TARONGA ZOO REPTILE AND AMPHIBIAN CONSERVATION CENTRE

Submissions Report
SSD-17483577

Prepared for
TARONGA CONSERVATION SOCIETY AUSTRALIA
20 October 2021

Figure 4 North Elevation

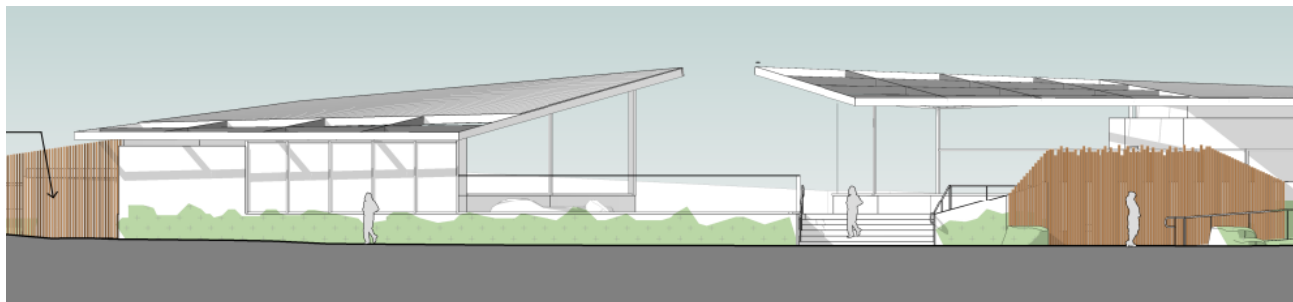
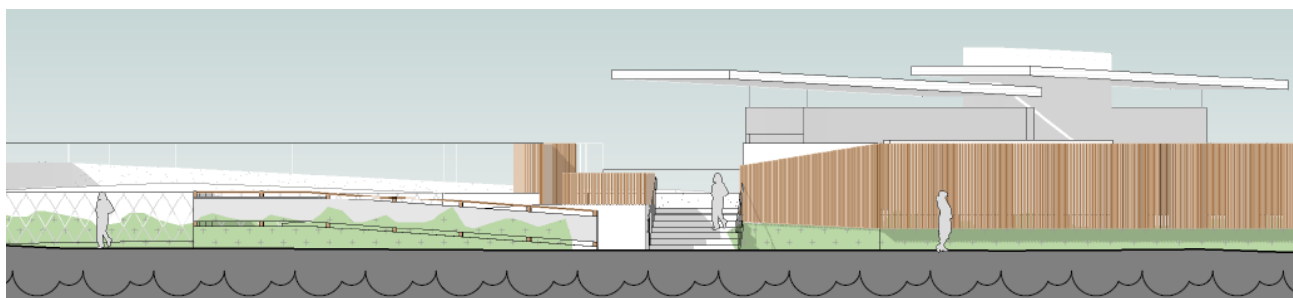
| Location | Proposed Refinements |
|---|---|
| Level 2 <i>Refer to Architectural Drawings AA1100, AA1203, AA1204, AA2000, AA3001, AA3002</i> | <ul style="list-style-type: none"> ▪ Reduction of overall floorplate, including reduction of shade structures and reconfiguration of animal exhibits ▪ Relocation of ramp and increase landscaping |

Picture 3 Original Proposed North Elevation

Picture 4 Amended North Elevation

Figure 6 View of RACC from Curraghbeena Lookout

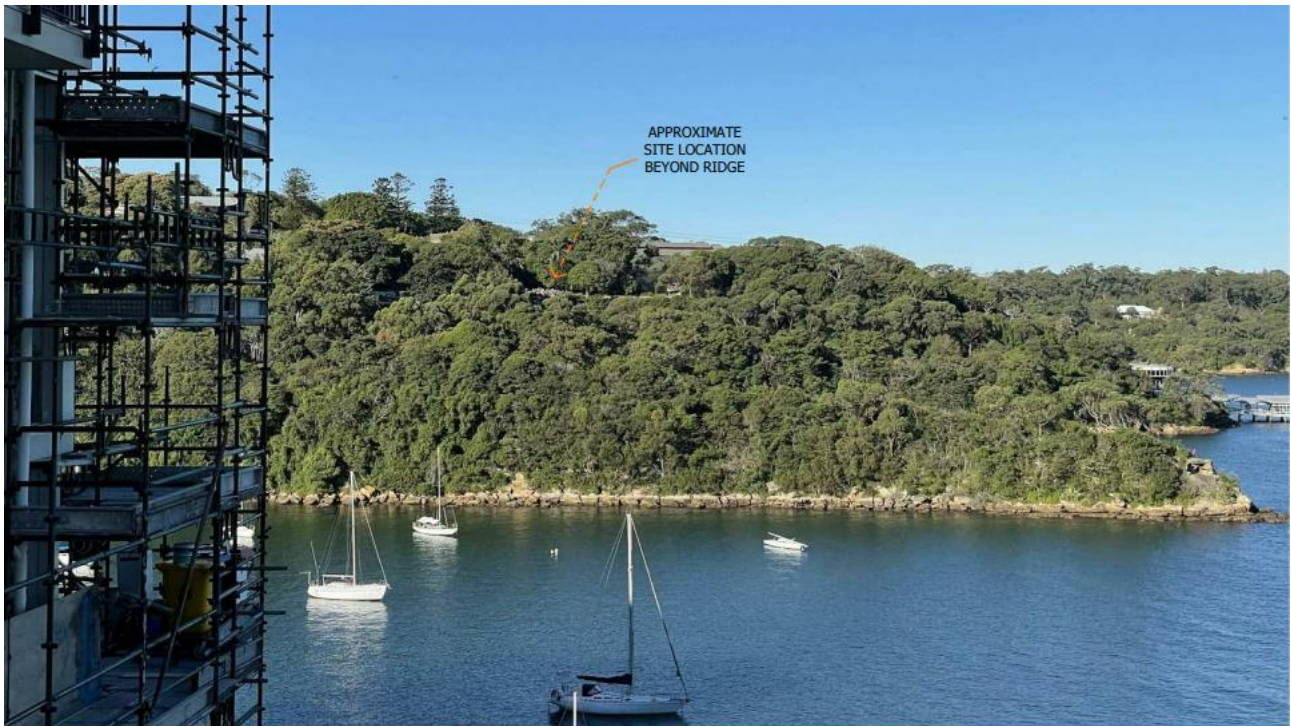
The SEARs required a Visual Impact Assessment, with photomontages, to be prepared to identify the potential visual impacts associated with the proposal when compared to the existing situation, when viewed to and from key vantage points, including Sydney Harbour, Curraghbeena Point and Cremorne Point. This was provided as part of the Design Report and Architectural Plans prepared by DWP as part of the original EIS Package. A summary of the findings of the amended Visual Impact Assessment in accordance with the SEARs is provided below.

No public access was available from Curraghbeena Point therefore **Figure 6** has been taken from Curraghbeena Lookout. Given the location of the RACC within the Zoo site, the facility is located beyond the ridge and will remain obscured by existing trees.

Figure 9 Conservation of significant bushland and other natural features

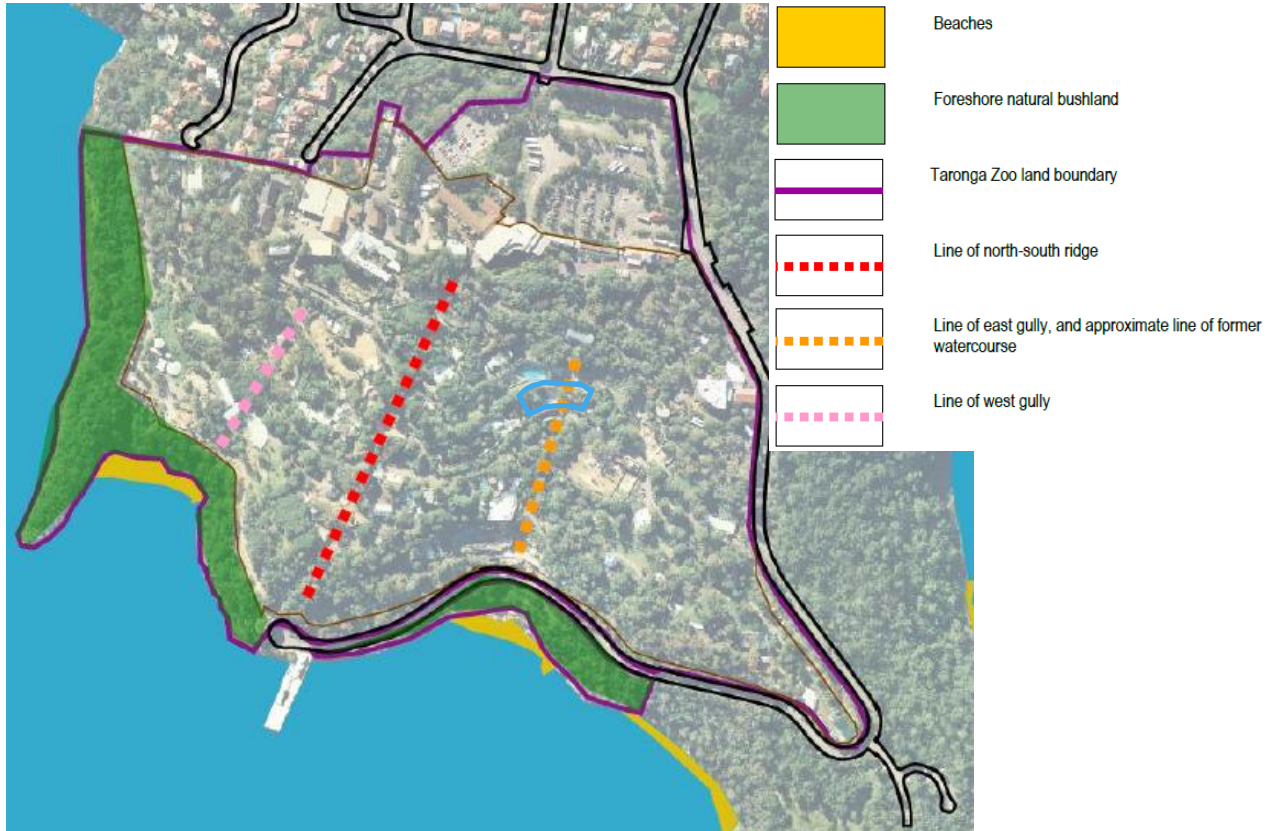
Some of the public submissions raised questions about the compliance of the proposed development with the Taronga Zoo *Urban Design Principles* which form part of the Zoo 2000 'The View to the Future' Master Plan. Further assessment and confirmation that the proposed development remains consistent with the relevant design principles of the Master Plan is provided in **Table 4** below.

Cutting north-south through the zoo is a steep ridgeline, with a well-contained gully located adjacent to the east, and a less prominent gully to the west. This gully runs through the RACC site (see **Figure 9**) and is interpreted into the landscape design. The line of the eastern gully is approximately the line of a former watercourse that ran north-south through the site.

Figure 12 Existing site photos

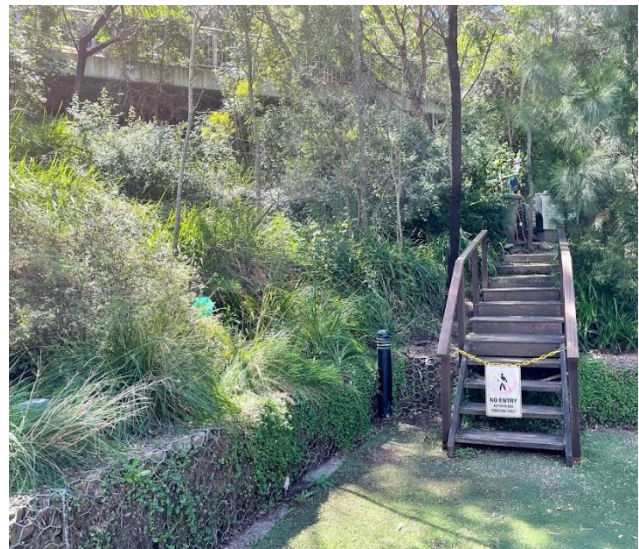
As noted in **Section 3.2** of this report, landscape plans have been amended to incorporate suitable canopy trees and additional green elements to maintain the dominance of landscaping over new built elements. Given the heritage elements including the aviaries, additional mature plantings are not feasible within the amended design.

As noted in the original EIS, trees proposed for removal are not native to the site and were planted in the past 10 years following the demolition of the Seal pools (see **Figure 12**). A majority of plantings proposed for removal are small shrubs with six high value trees (Trees 1-6) proposed for retention and an additional seven high value trees (Trees 9, 10, 16, 21, 23 & 24) to be relocated within the RACC site or within the Zoo. As noted in the amended Arborist Report (**Appendix M**) all trees proposed for removal are to be replaced locally endemic or non-endemic and correspond to the natural habitat of the species within the RACC exhibit. The following replacement strategy for all tree removal on site is proposed:

- All high retention value trees (9 trees) shall be replaced at an off-set ratio of 2:1, with 2 x 100 litre pot size tree species for every tree removed.
- All moderate value trees (4 trees) shall be replaced at an off-set ratio of 2:1, with 2 x 75 litre pot size tree species for every tree removed.
- All low value trees (30 trees) shall be replaced at an off-set ratio of 1:1, with 1 x 25 litre pot size tree species for every tree removed.

Figure 13 Refined Landscape Design

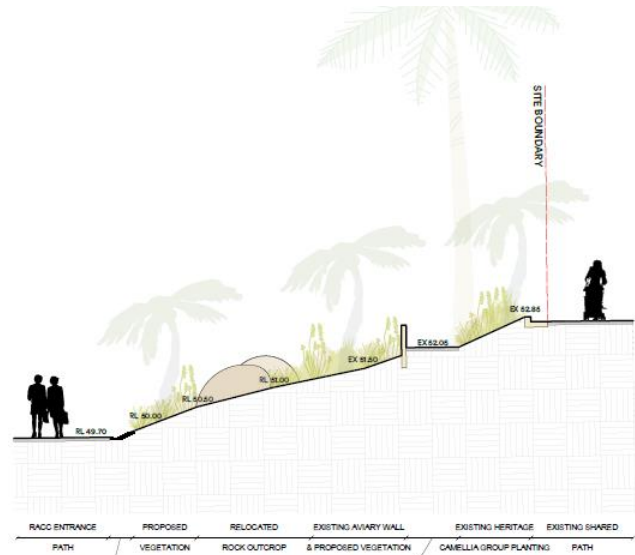
DPIE requested clarification into consultation undertaken with the Taronga Aboriginal Advisory Group (TAAG) and Indigenous staff. Consultation was undertaken on 25 May 2021 and 16 June 2021, with members of the TAAG and Indigenous staff.

In response to these consultation processes including thorough advice received from Traditional Custodians and represented RAPs, interpretation of Country has been incorporated into the landscape design including the retention and re-use of the sandstone boulder on site in the landscape design.

The re-use of this boulder as a landscape element in the design also interprets the original sandstone landscape of the Bradley's Head Peninsula and evokes a Connection to Country through the retention and interpretation of original landscape elements. Other elements have been incorporated into the design including interpretive signage and plantings. Further details are incorporated into the amended Landscape Package enclosed in **Appendix E**.
